7A Design Response to Appendix B, ABWR LRB Instrumentation and Controls

7A.2 [Multiplexing Systems

Figure 7A-2 Structure for Control and Instrumentation System Design

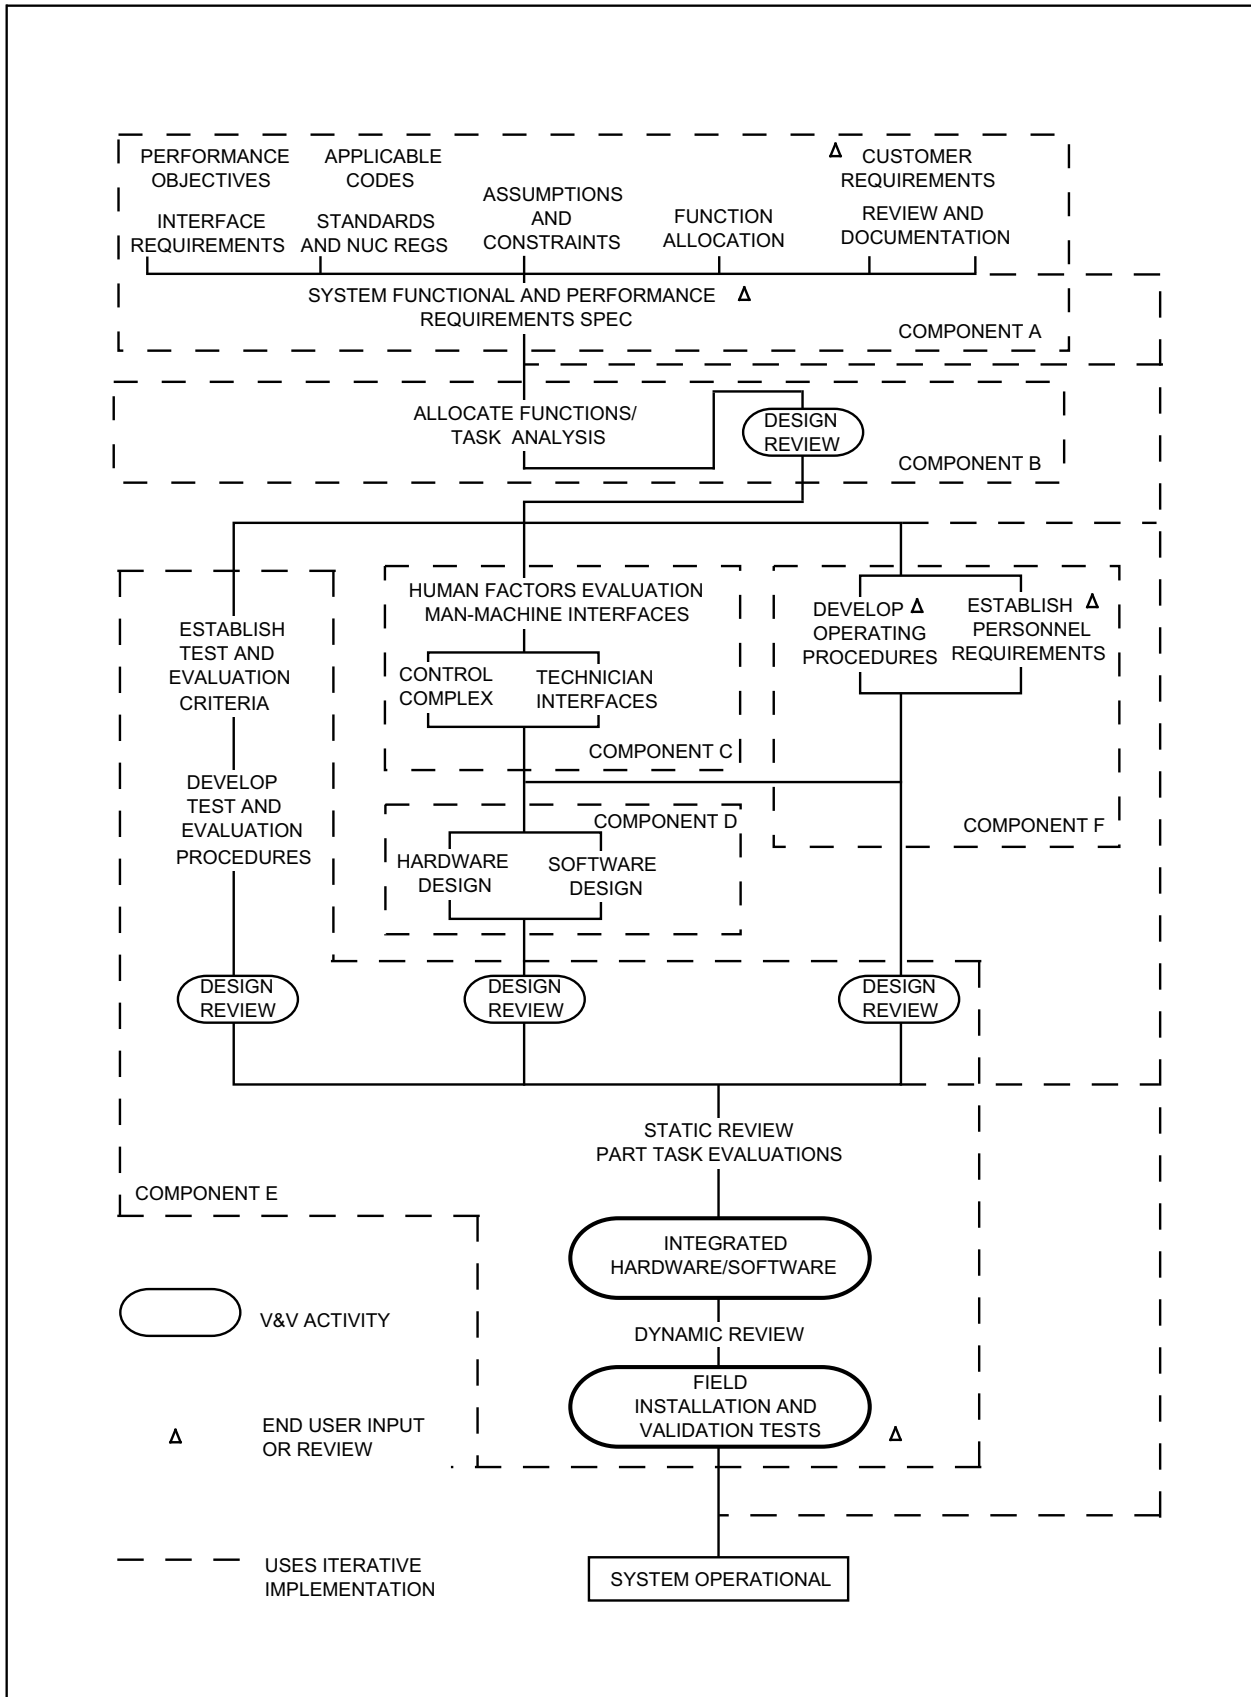
Items 7A.5(1) and 7A.5(2)

Criteria and guidelines stated in ANSI/IEEE-ANS-7.4.3.2, as endorsed by Regulatory Guide 1.152, have been used as a basis for design procedures established for programmable digital equipment.

A structured, engineered approach to the development of both hardware and software is implemented to assure that the design proceeds along the lines of the requirement specifications and has traceable documentation.

Verification and validation (V&V) includes the establishment of test and evaluation criteria, the development of test and evaluation procedures, the testing of the integrated hardware and software, and the installation of the hardware and software in the field.

In accordance with the step-by-step verification process, design reviews are performed at the system functional and performance requirements specification/task analysis and allocation of functions level, the hardware design and the software design level, the test and evaluation criteria and procedures level, and the personnel requirements and operating/maintenance plan level. Such reviews are conducted by knowledgeable and experienced system engineers, software engineers, hardware engineers, etc., who are not directly responsible for the design, but who may be from the same organization.

Figure 7A-2 illustrates the structure utilized for ABWR control and instrumentation system design which incorporates subject guidelines.
